**ARCHITECT'S ADDENDUM**

Addendum Number: 01

RE: Fort Zumwalt School District

Transportation Center

1 FLOOR PLAN - PLUMBING & FIRE PROTECTION  
1/8" = 1'-0"

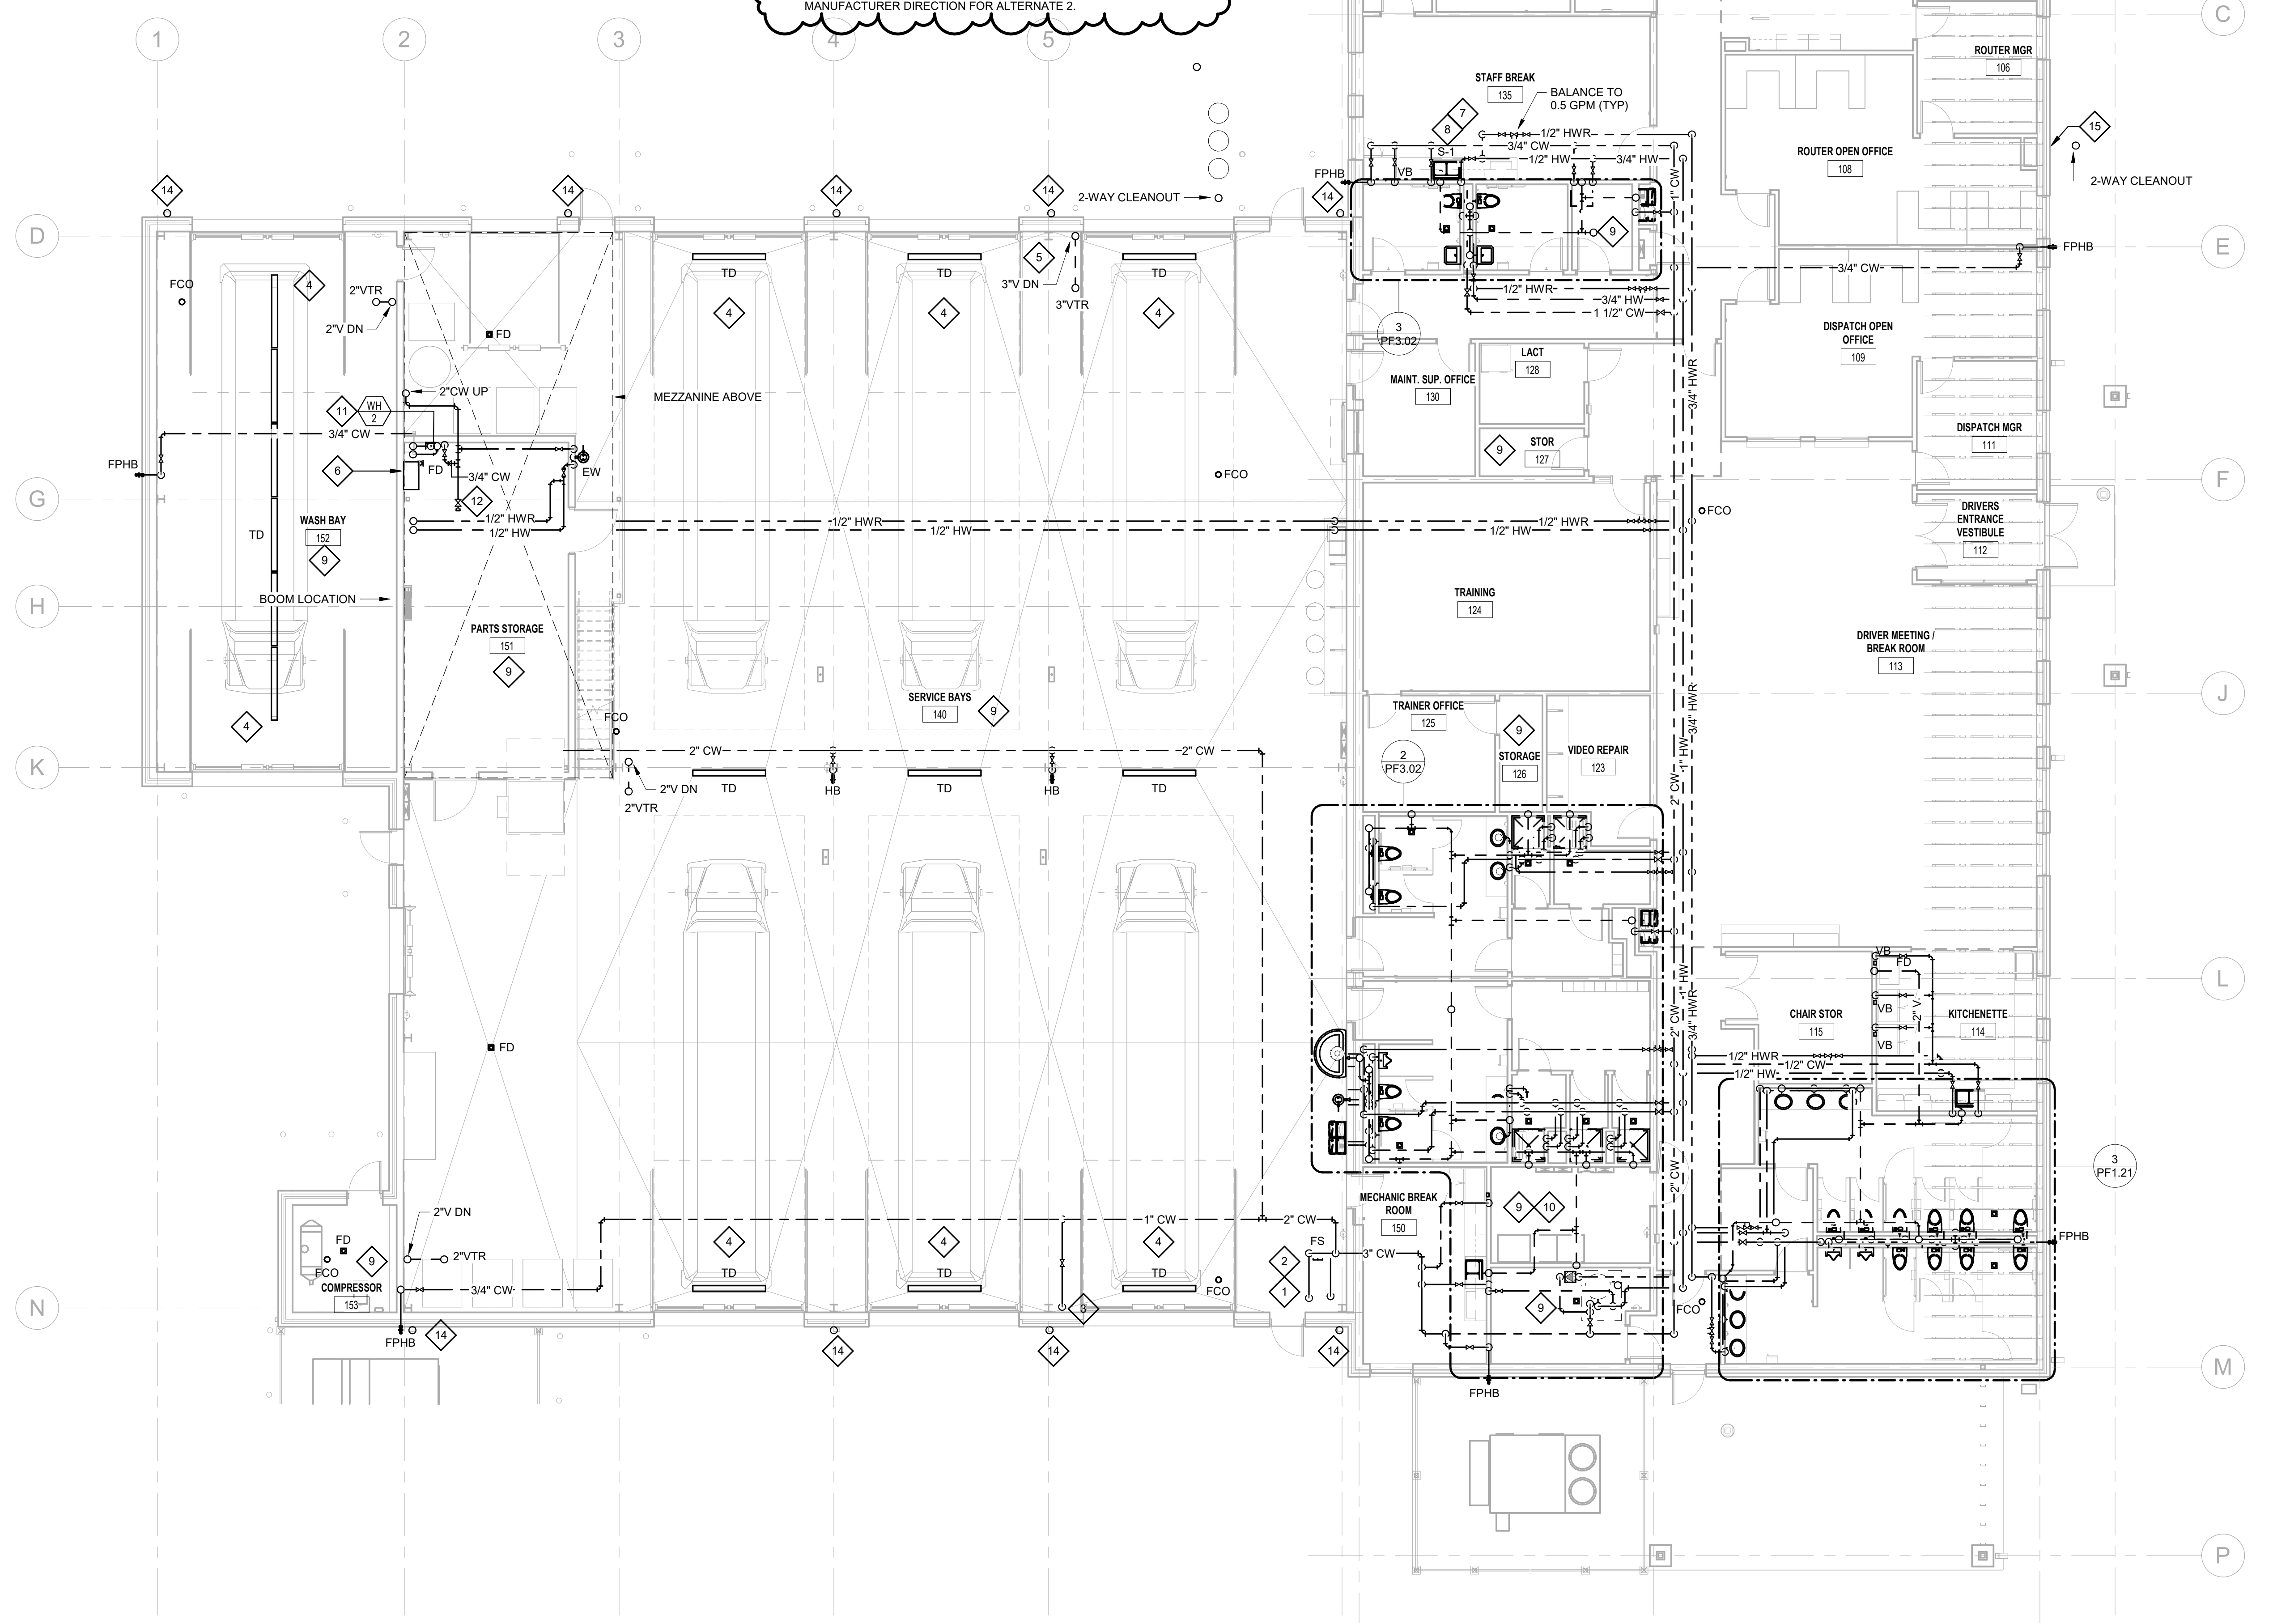
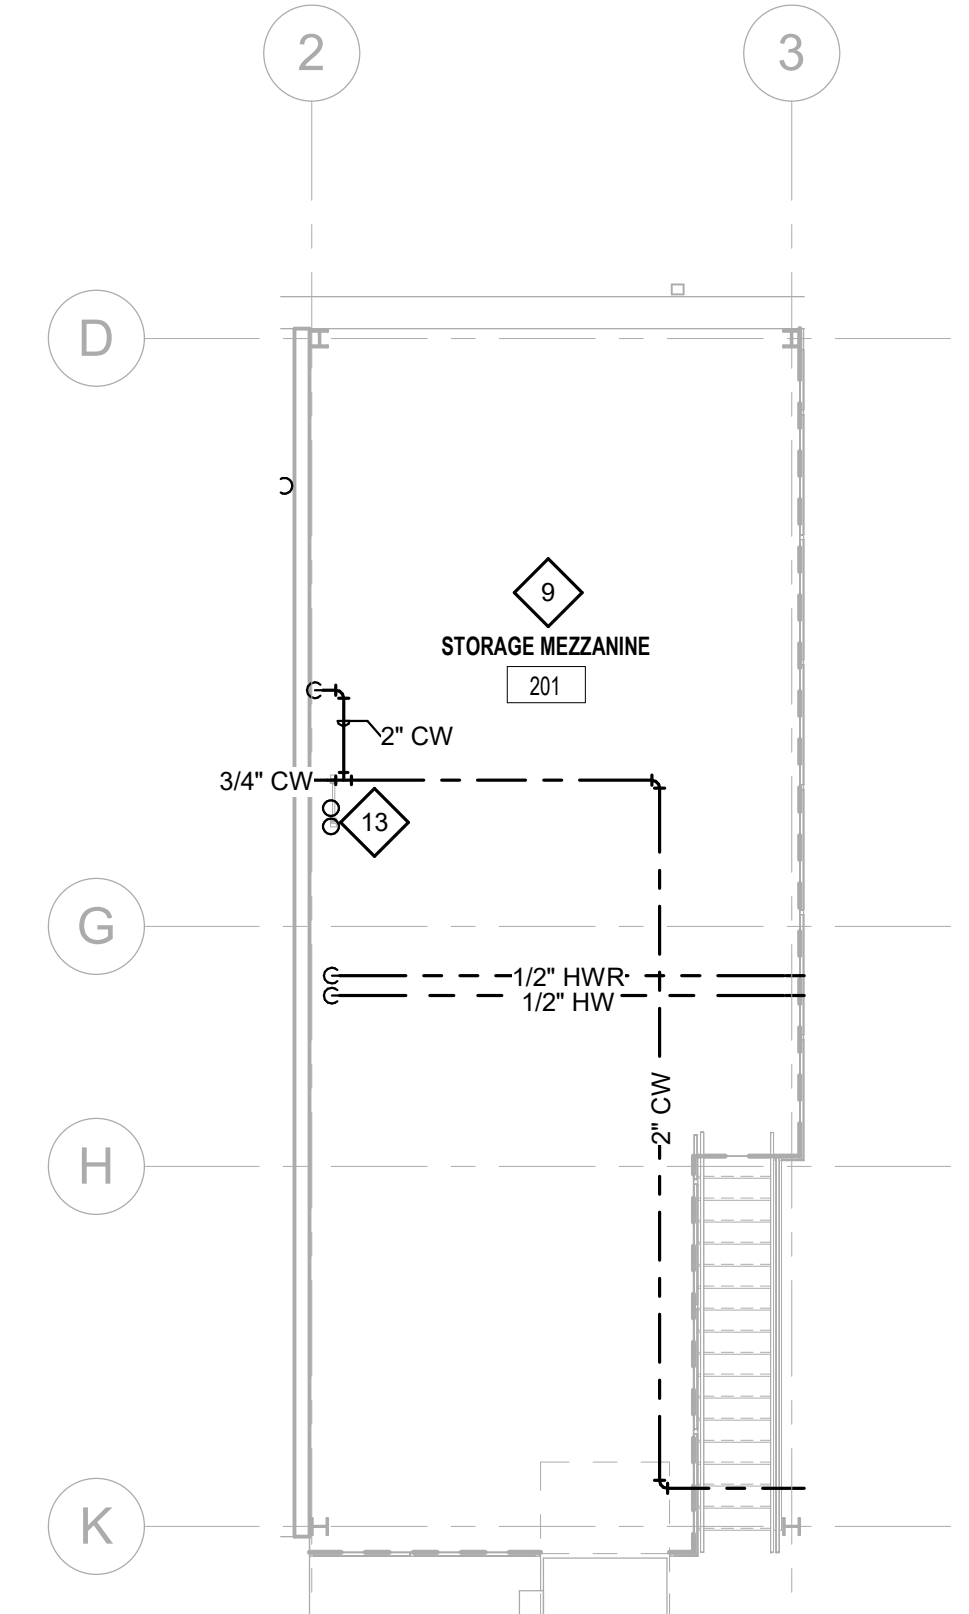
Q – Can it please be verified that no additional backflow protection will be required in the parts storage area to isolate the car washing equipment from the domestic system supplying the rest of the facility? If the car wash equipment will include a chemical feed system for soaps/detergents the AHJ may require additional backflow protection for this equipment.

- b. Exhaust clarification – duct size added to Wash Bay 152 exhaust duct (16"x16").
16. PF1.21
  - a. Added RPZ to keyed note 12 for automated washbay equipment feed water.

A – See revised drawing this addendum
